**BEFORE THE PUBLIC UTILITIES COMMISSION
OF THE STATE OF CALIFORNIA**

Order Instituting Investigation pursuant to Senate Bill 380 to determine the feasibility of minimizing or eliminating the use of the Aliso Canyon natural gas storage facility located in the County of Los Angeles while still maintaining energy and electric reliability for the region.

Investigation 17-02-002
(Filed February 9, 2017)

SIERRA CLUB COMMENTS ON NOVEMBER 3, 2021 WORKSHOP

Figure 1: Systemwide Straight-Line Building Emission Trajectories of Scenarios Compared to 2045 Carbon Neutrality¹¹

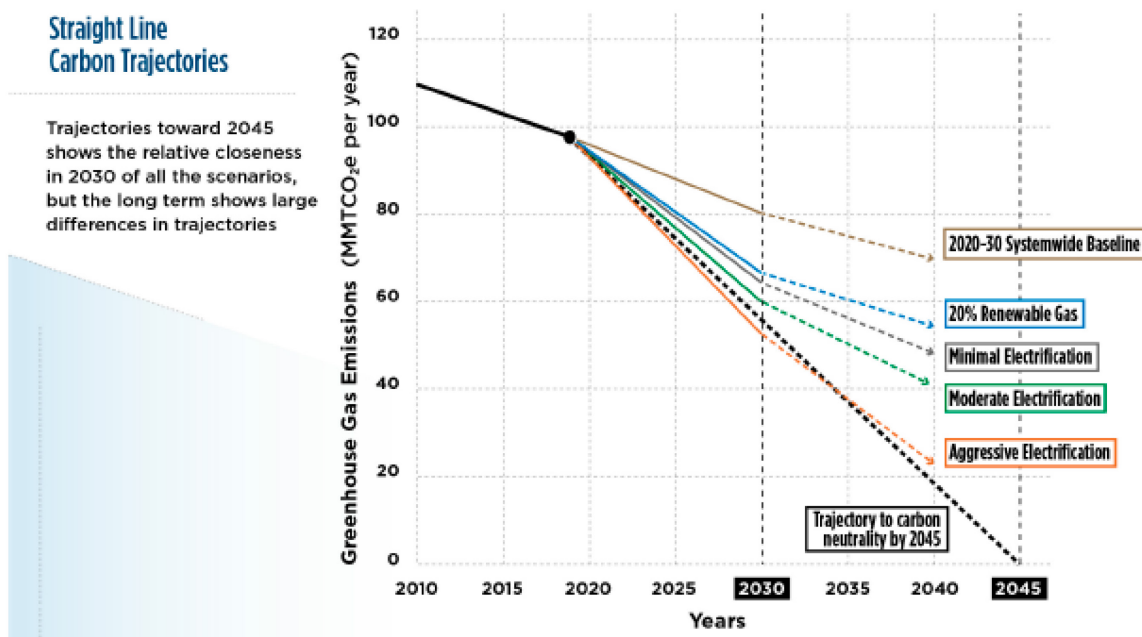
Slide 42 of the FTI Presentation states that the “[l]evel of electrification is assumed to be at the Moderate Electrification level of the CEC’s 2021 California Building Decarbonization Assessment.” The Moderate Electrification Scenario assumes 100 percent new all electric construction, 50 percent replacement of gas with electric appliances, and five percent early retirement of gas appliances by 2030.¹⁰ Under the CEC’s analysis, this scenario falls short of aligning with California’s decarbonization objectives.

retirement of gas appliances by 2030.¹² It is important to understand the impact on the ability to close Aliso Canyon under a building electrification scenario that is at the pace necessary for California to meet its carbon neutrality requirements. This scenario should be modelled.

Figure 2: Single-Family Residential HPWH Electric Load¹⁹

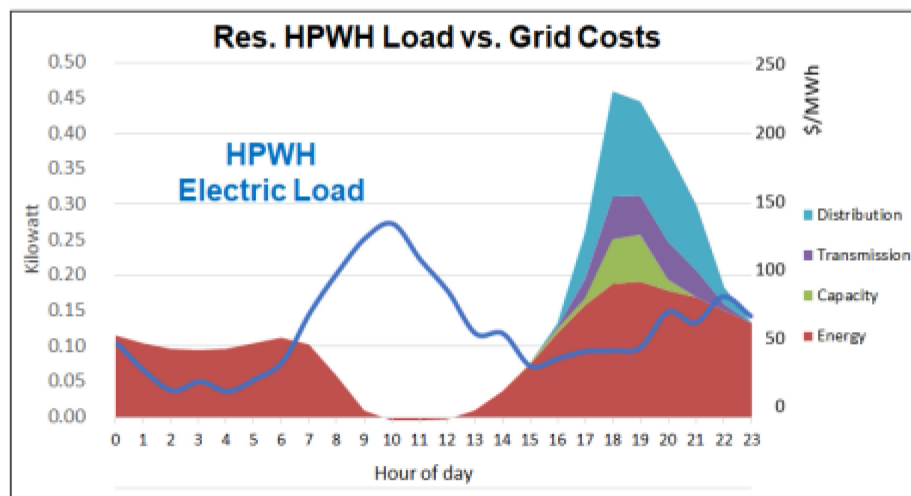
With regard to the hourly load shape Slide 42 of the FTI Presentation states is provided by AGA information, none of it appears in the referenced AGA Study and it is unclear where this information was derived. The FTI Electrification Hourly Demand spreadsheet on the Commission’s Aliso Canyon webpage also contains no citation to a data source.¹⁷ Like data on appliance efficiency, it is unclear why FTI opted to use information from the AGA when the CEC’s Title 24 Compliance software should have hourly load information for space heating by climate zone. The FTI spreadsheet also assumes HPWHs operate consistently across all hours. In fact, as noted in the Commission’s HPWH Staff Proposal for the SGIP proceeding, “HPWH’s electrical demand curve peaks during the middle of the day (i.e., off-peak hours) when renewable generation, especially utility-scale and rooftop solar are greatest.”¹⁸

HPWHs can also be programmed to shift load and pre-heat water ahead of peak demand times to further limit peak demand impacts. This is not just a theoretical possibility; the Commission and stakeholders should anticipate that any targeted electrification programs that arise from this proceeding take advantage of these capabilities by, for instance, making it a standard practice for the hired installers to program HPWHs to heat at mid-day. ***Please explain how the AGA data was used to determine model outputs and replace with CEC data. Please also indicate the extent costs and impacts that can be mitigated with demand responsive HPWHs.*** This is the type of information that is needed to inform potential action by the Commission in deploying effective solutions to shut down Aliso Canyon.

Figure 3: Potential for Storage to meet LA Basin needs²²

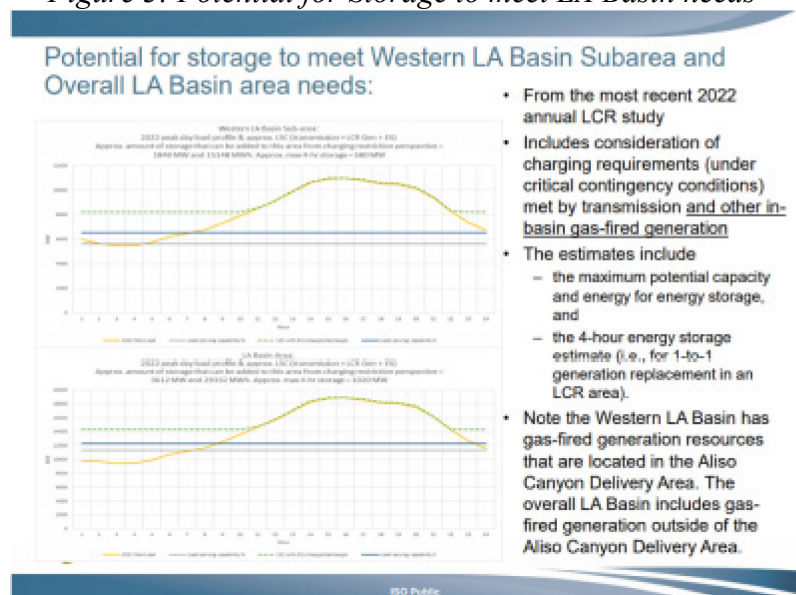
In addition, local areas and sub-areas have limited transmission capability and therefore rely on in-basin resources to be available to serve local need in the event of a transmission contingency. For batteries to displace other local capacity resources in the event of a transmission outage, remaining “resources must be sufficient to recharge the batteries in anticipation of the outage continuing through the night and into the next day’s peak load period.”²⁰ Local capacity areas with significant amounts of gas generation in disadvantaged communities such as Western LA Basin are largely developed and therefore cannot accommodate utility-scale renewables to serve as a local generation source to charge batteries in the event of an extended transmission contingency. For example, CAISO analysis indicates that 4-hour battery storage could displace 580 MW in the Western LA Basin and slightly over 1 GW for the entire LA Basin on a 1-to-1 basis.²¹

The model also does not appear to account for transmission constraints in determining resource effectiveness. Resources deployed outside the LA Basin do not meet local capacity requirements, necessitating continued reliance on gas generation in the LA Basin. Sierra Club has long advocated for in-basin storage procurement to, at a minimum, meet the current limits on 4-hour storage in meeting local area need. To the extent other resources are assumed to be deployed in the FTI Study, their effectiveness at reducing reliance on gas generation in the LA Basin when local capacity constraints are accounted must be better understood to have confidence that they will be effective in reducing reliance on Aliso and so that the Commission has reliable information to direct procurement in those areas.
